ANN ARBOR HISTORIC DISTRICT COMMISSION

Staff Report

ADDRESS: 215 N. Division Street, Application Number HDC15-241

DISTRICT: Old Fourth Ward Historic District

DETAIL OF BASEMENT WINDOW

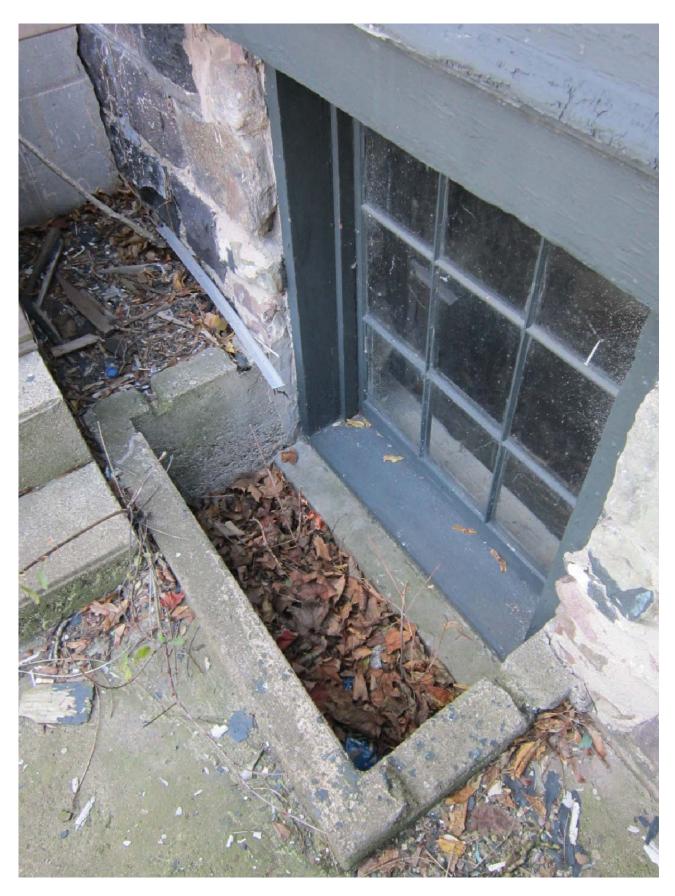
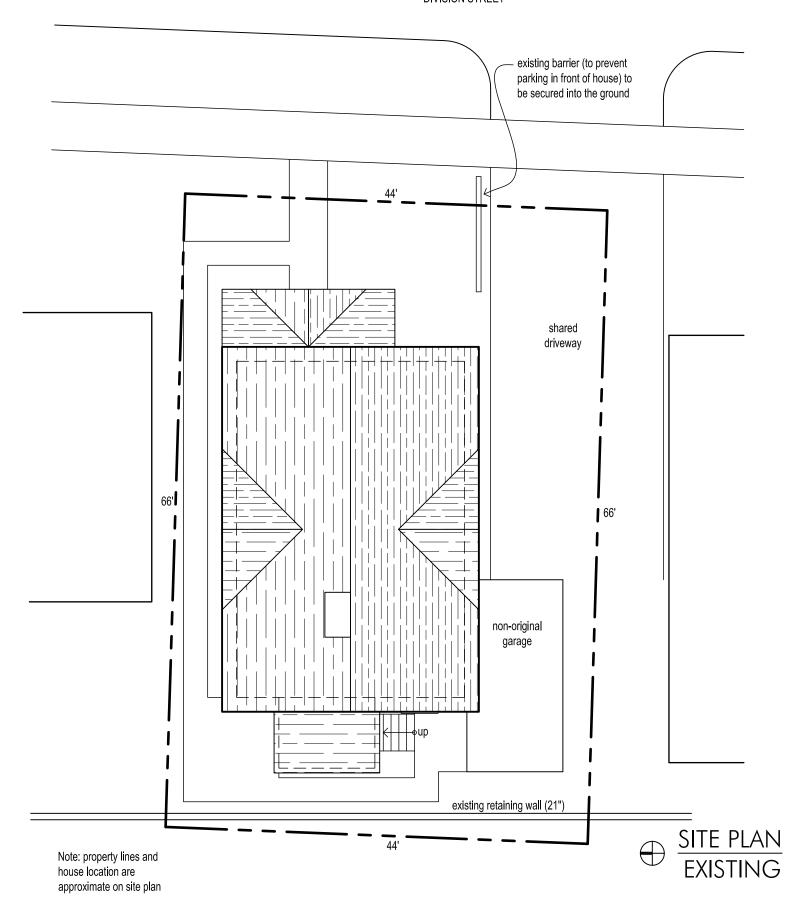
- 2. The house has one other basement window, located on the center of the south elevation. It is not a candidate for egress since a window well would interfere with the driveway. The proposed egress window location, on the rear elevation between the garage and the back porch, requires that the steps to the non-original back porch be rotated to face west instead of south. A drawing is provided showing the new wood stair and wood railing, of an appropriate simple design.

PROPOSED WINDOW

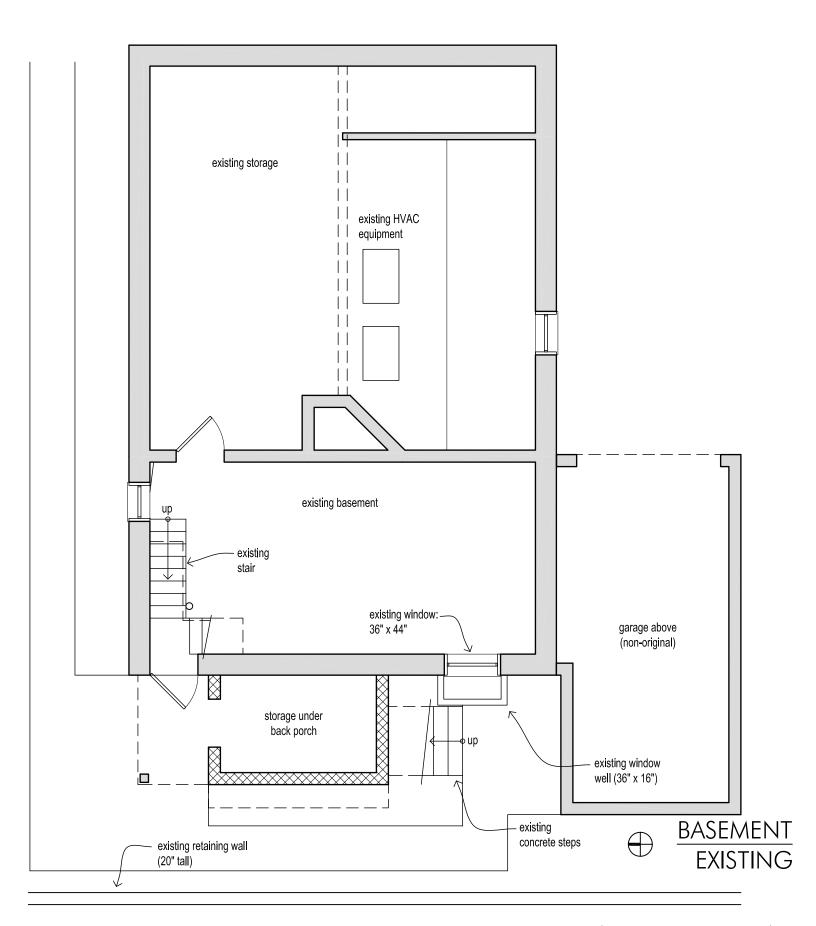
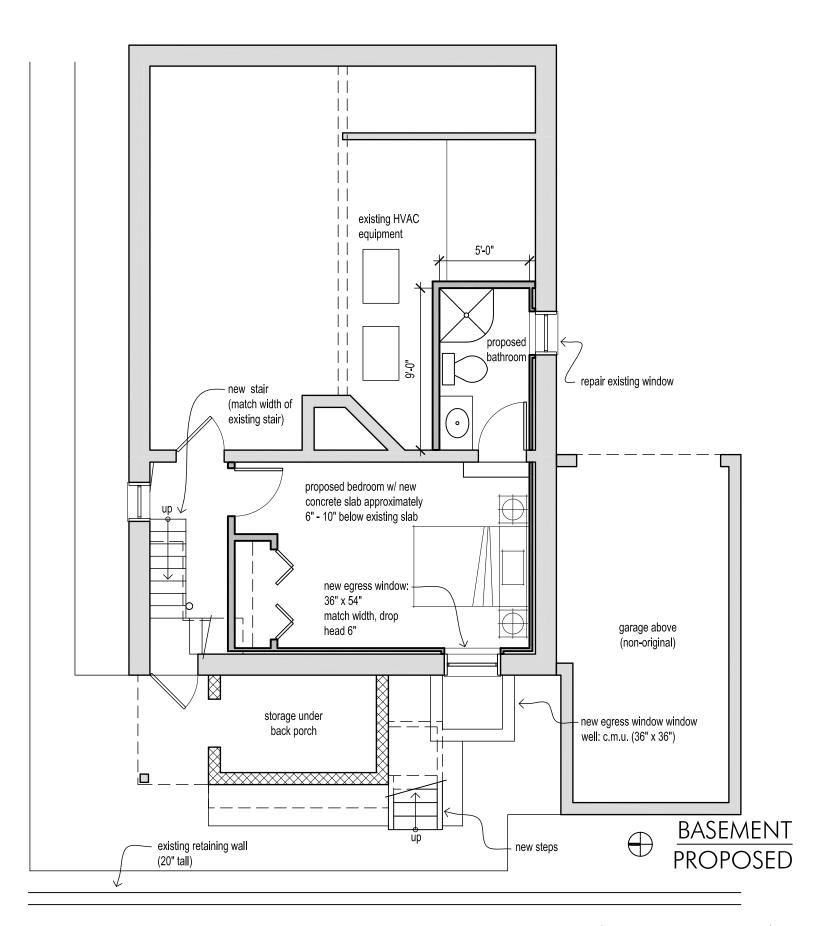
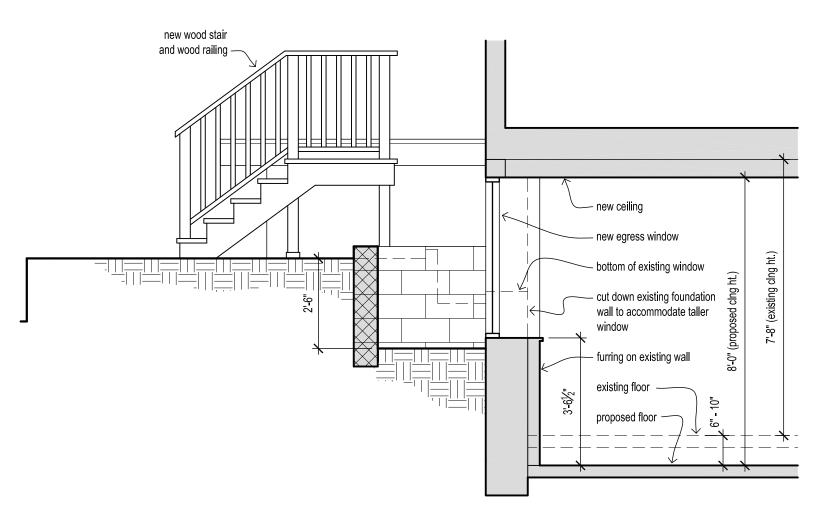
- 1. The house is a rental duplex with a two-bedroom apartment on the first floor, and a four-bedroom apartment on the second and third floors. The property owner desires to finish a room in the basement as a third bedroom for the lower apartment, which will require the installation of an egress window. The size of the lot prohibits an addition on the back (the backyard is only around 8' deep). The basement egress window would replace an existing nine-lite window on the west elevation that is assumed to be original or from the period of significance for the historic district (pre-1944). The existing window is 36" x 44" and has a 36" x 16" shallow window well. The egress window is 36" x 54" and matches the width of the existing window. The egress window swings inward. The well is construction of concrete masonry units and projects out 36" from the face of the window, is 30" deep and 36" wide.

- Landscape timbers along the driveway near the street are proposed to be anchored in place to prevent cars from parking in the front yard. This work is appropriate and appreciated. Staff's proposed motion conditions the issuance of permits on this work's completion.
- 4. Staff feels that the proposed egress window is appropriately located, and the new stairs will be an improvement over the current concrete ones.

I move that the Commission issue a certificate of appropriateness for the application at 215 N. Division Street, a contributing property in the Old Fourth Ward Historic District, to add a driveway barrier and basement egress window, and relocate rear stairs, on the condition that the proposed barrier is secured along the driveway near the street prior to the issuance of building permits. The work is compatible in exterior design, arrangement, texture, material and relationship to the rest of the building and the surrounding area and meets the *Ann Arbor Historic District Design Guidelines*, especially those for windows, and the *Secretary of the Interior's Standards for Rehabilitation* and *Guidelines for Rehabilitating Historic Buildings*, in particular standards 2, 9 and 10 and the guidelines for windows.
